Field Service Information

No. 04/12

Dialog+
Dialog+ SW 9.xx

Continuous Quality Improvement: New Pressure Reducer Valve DMV

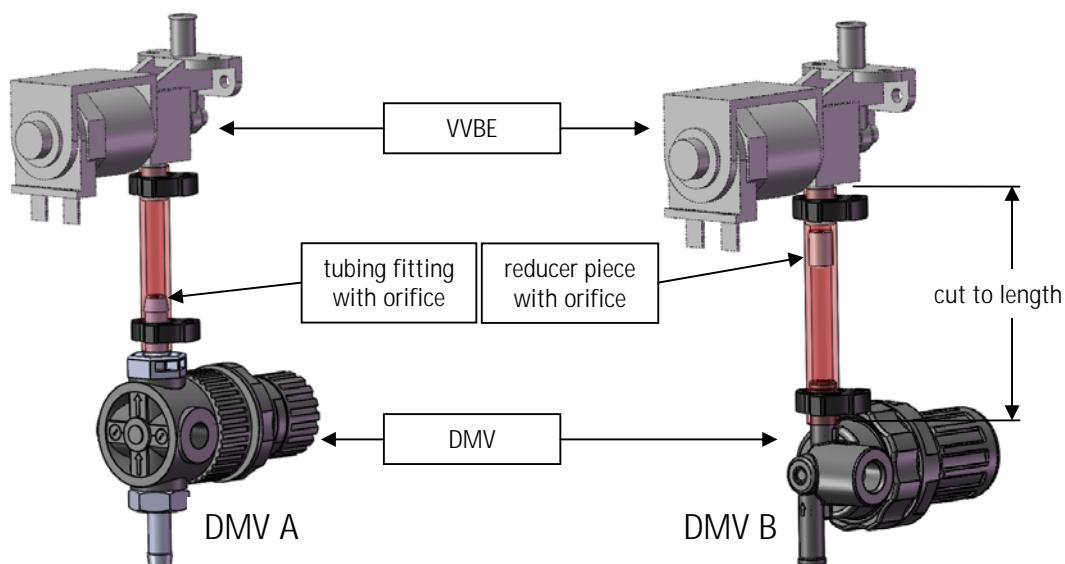
We have modified the Pressure Reducer Valve DMV, necessary for the regulation of the incoming water pressure, in our continuous strive for quality improvement.

The tubing length between the DMV and the water inlet valve VVBE has to be adjusted in the case of replacement of the current DMV A (with screw-type tubing fittings) against the new DMV B type (moulded tubing fittings). Additionally, the tubing length depends on the type of valve VVBE used (refer to table).

In addition, a flow restrictor with an orifice has to be installed into the tubing in front of the VVBE to create a defined flow resistance inside the water inlet. The current DMV has this restrictor integrated inside the tubing fitting.

The setting values for the DMV remain the same as before, i.e. 1.0 bar to 1.3 bar for Dialog+ and 0.9 bar ± 0.1 bar for Dialog+ SW 9.xx respectively (refer to the calibration procedure in the respective Service Manual).

The attached tubing and reducer piece are not required if the type of DMV B is already present.
